### **End of Sale Notification for Carbon Steel Miniature Linear Guide Products of MISUMI**

**Sheet No.1**

**Material Modification, from Carbon Steel to Stainless Steel, of Miniature Linear Guides**

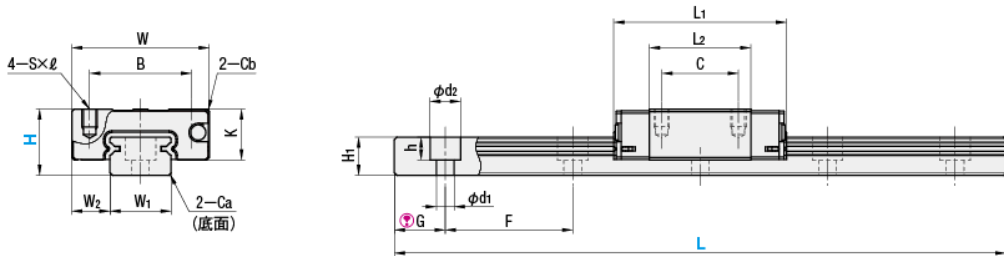
Material will be modified from Carbon Steel to Stainless Steel. There is no modification in Specification, Allowable Load Capacity, Allowable Moment, Standard Accuracy, and the others.

For instance: S(S)EB10-55 Example of Specification Comparison

In order to modify Model No. to Stainless Steel Product, please add a [S] to the top of Carbon Steel Products model No. For Low temperature black chrome plating product, please add a [S] next to [R].

[Carbon Steel] S E B 10 - 55 ⇒ [Stainless Steel] S S E B 10 - 55

[Carbon steel] R E B 10 - 55 ⇒ [Stainless Steel] R S E B 10 - 55
